Item Name: Crosstube Turning Detail

DART AEROSPACE LTD		Work Order: 87560
Description: Crosstube Assembly (205/212/412 High Fwd)		Part Number: D212-664-141
Inspection Dwg: D212-664-141 Rev: D		Page 1 of 2

DRAWING NO. D212-664-141	TITLE XTUBE ASSY (205/212/412 HI FWD)	REV. D	DART AEROSPACE LTD ENGINEERING ORDER		D.E.O. NO. D212-664-141-D-1	SHEET NO. SHEET 1 OF 2	SCALE NTS
DRAWN	CHECKED	MFG. APPR.	APPROVED	DE APPR.			
DATE 11.04.07	DATE 11.04.11	DATE 11.04.12	DATE 11/04/12	DATE 11.04.12

DRAWING NO. D212-664-141	TITLE CROSSTUBE ASS'Y (205 HI FWD)	REV. D	DART AEROSPACE LTD ENGINEERING ORDER		D.E.O. NO. D212-664-141-D-2	SHEET NO. SHEET 1 OF 1	SCALE NTS
DRAWN <i>UP</i>	CHECKED <i>ASS</i>	MFG. APPR. <i>AS</i>	APPROVED <i>MD</i>	DE APPR. <i>TH</i>			
DATE 11.07.15	DATE 11.07.20	DATE 11.07.21	DATE 11/07/21	DATE 11.07.21

**D212-664-141/-141B
ASSEMBLY DETAIL**

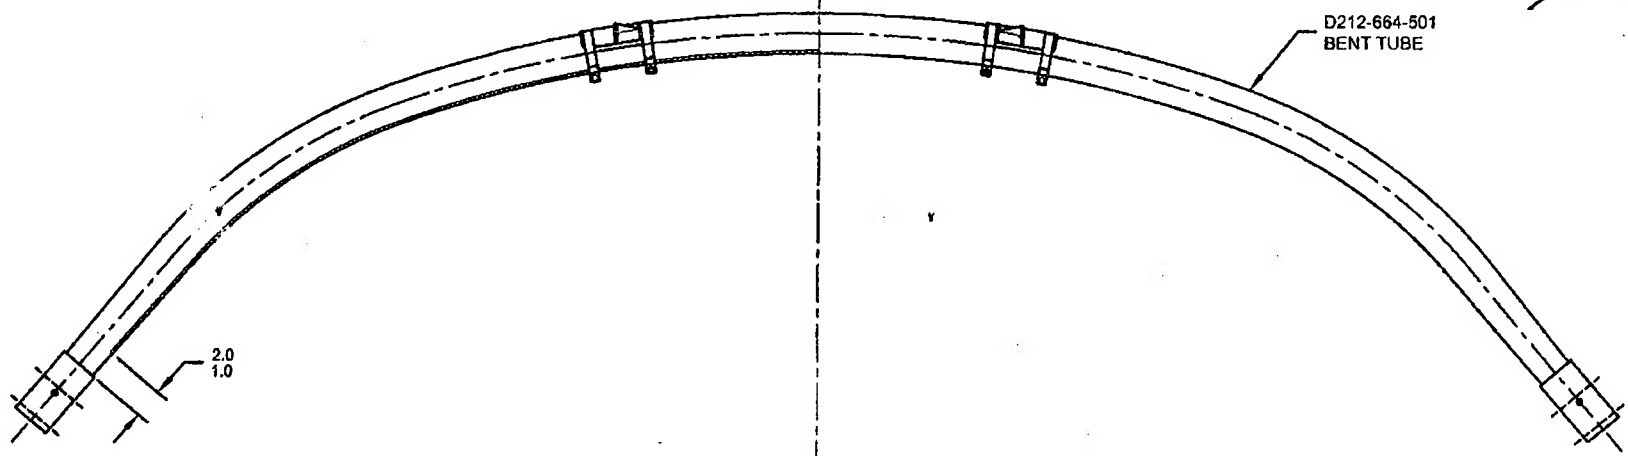
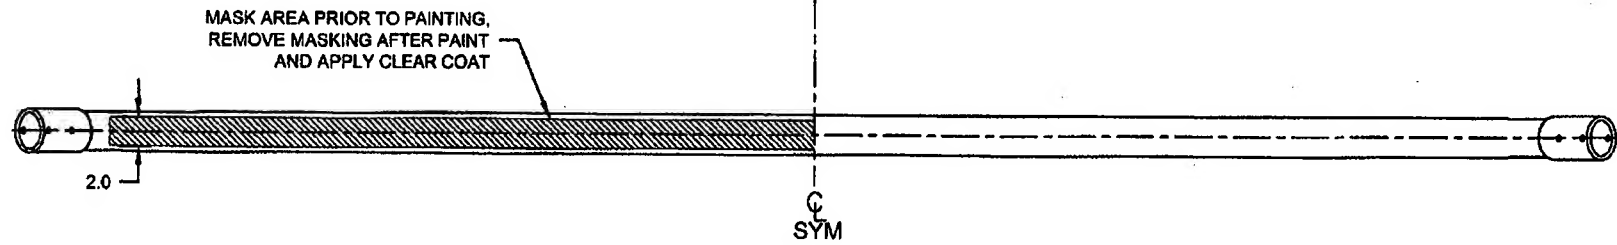
ADD AN INSPECTION WINDOW TO UNDERSIDE OF CROSSTUBE.

- 2) FINISH: CHEMICAL CONVERSION COAT PER DART QSI 005 4.1
PRIME INSIDE AND OUTSIDE PER DART QSI 005 4.2
MASK UNDERSIDE OF CROSSTUBE AS SHOWN (HATCHED AREA) AND
PAINT OUTSIDE PER DART QSI 005 4.2
REMOVE MASKING AND APPLY CLEAR COAT
